Topic	V8T- Alternator - Water deflection shield (SC13/13)
Market area	Worldwide Bentley (1WBE)
Brand	Bentley
Transaction No.	2033404/1
Campaign number	E789
Note	
Type	
US code

New Continental GT V8 and GTC V8

V8T- Alternator - Water deflection shield (SC13/13)

Figure 1

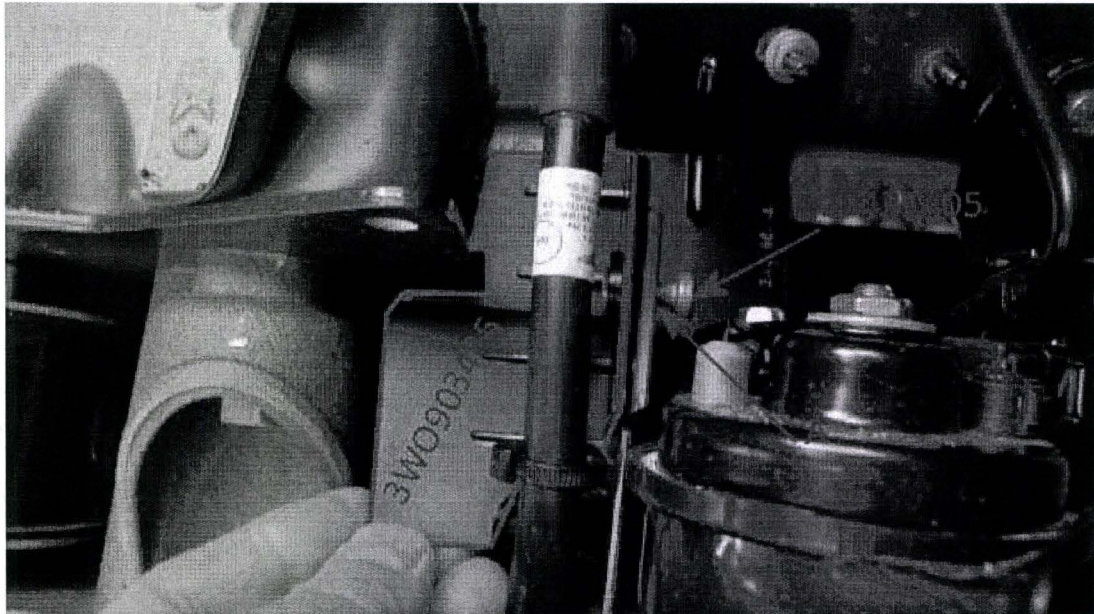
4. Referencing figure 1 fit the new splash shield part number 3W0903445 to the original horn support bracket utilising the existing hole (A). Secure the new shield with M6 screw N10451405. Tighten

M6 screw to 6Nm
